TABLE OF CHANGES FOR PLANNING
AMMENDMENTS: SECTIONS & ELEVATIONS

SUMMARY OF CHANGES BETWEEN CONSENTED
PLANNING DRAWINGS, AS PER APPLICATION
REF 126648/FO/2020 AND RESUBMITTED PROPOSED
MMA APPLICATION DRAWINGS:

Drawing Number	Revision																																																								
6555-P-B500-E-E-001	E

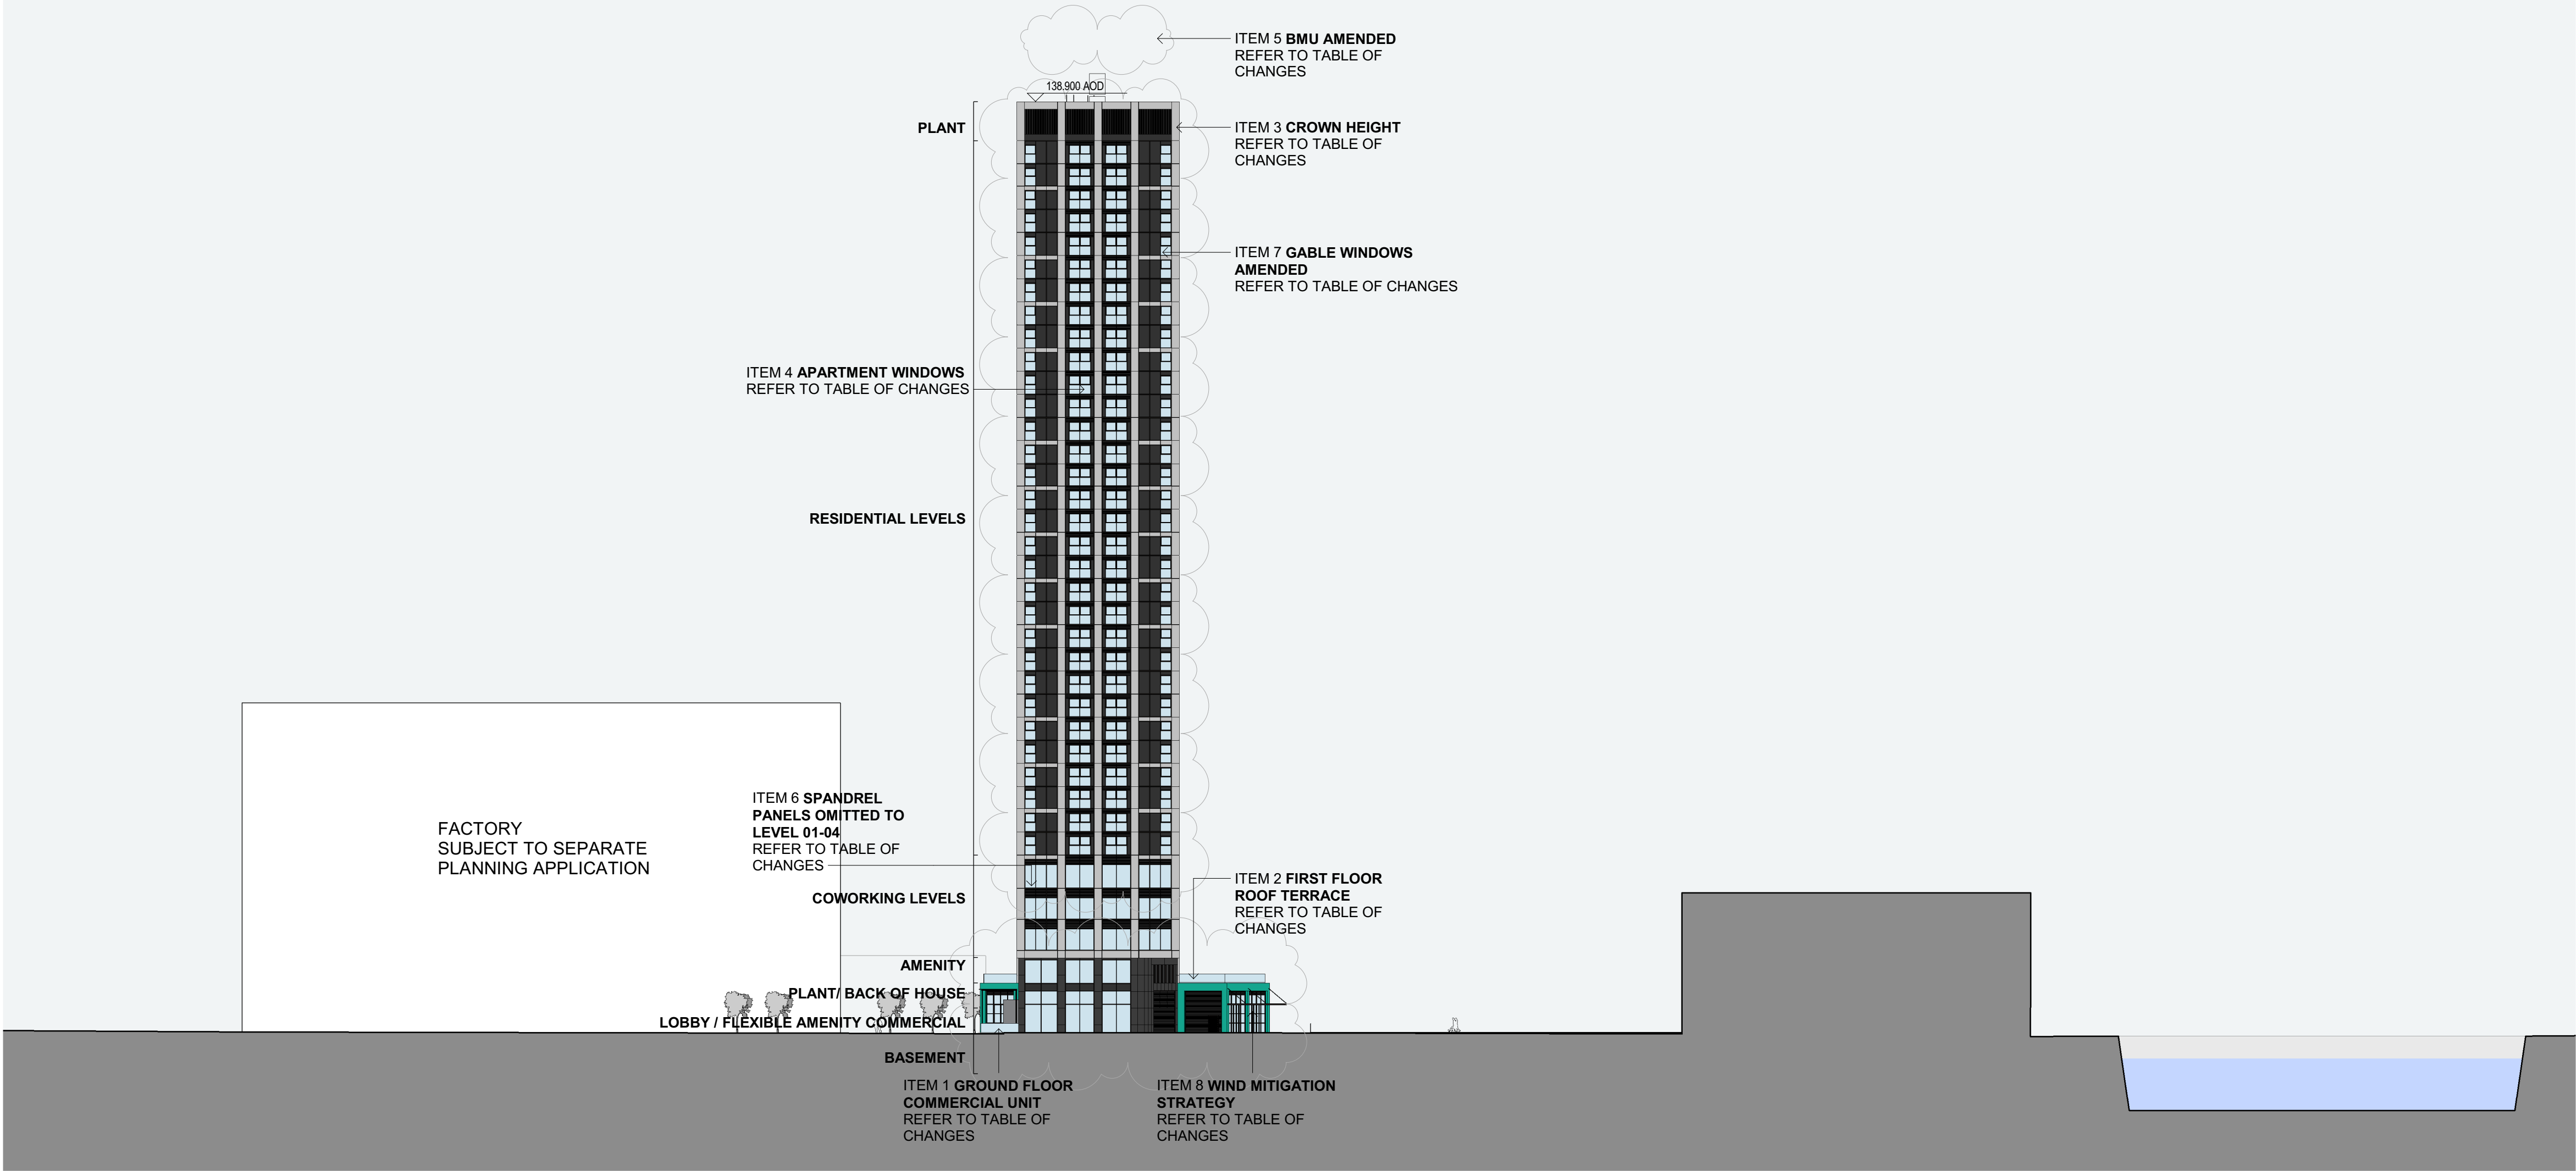
- 1 - GROUND FLOOR COMMERCIAL UNIT**
GROUND FLOOR FOOTPRINT DEVELOPED TO INCLUDE
COMMERCIAL UNIT
- 2 - ROOF TERRACE**
INTRODUCED AT LEVEL 01 WITH GLAZED
PERIMETER BALUSTRADE

- 3 - CROWN HEIGHT**
HEIGHT OF CROWN REDUCED BY 1.31M
OVEREALL BUILDING HEIGHT REDUCED TO 112M
- 4 - APARTMENT WINDOWS**
SIZE / CONFIGURATION OF APARTMENT WINDOWS
TO RESIDENTIAL FLOORS AMENDED

- 5 - BMU AMENDED**
STATIC ROOF-MOUNTED MAINTENANCE UNIT (BMU)
AMENDED TO MOBILE PERIMETER TRACK-MOUNTED
TYPE BMU WHICH WHEN PARKED IS FULLY
CONCEALED
- 6 - SPANDREL PANELS OMITTED AT LEVEL 01-04**
FIXED GLAZED SPANDREL PANELS TO BOTTOM OF
LEVEL 01-04 GLAZED SCREENS OMITTED TO NOW MAKE
THE SCREENS FULL HEIGHT

- 7 - GABLE FACADE AMENDED**
SIZE AND CONFIGURATION OF WINDOWS FIIXED CLEAR
GLAZING AND METAL FACADE PANELS AMENDED TO
ALIGN WITH SPECIALIST DESIGN ADVICE

- 8 - WIND MITIGATION STRATEGY**
ADDITIONAL TREES, CANOPY,WALKWAY ARCHES,
BALUSTRADES AND SCREENS INTRODUCED FOLLOWING
WIND MITIGATION ANALYSIS
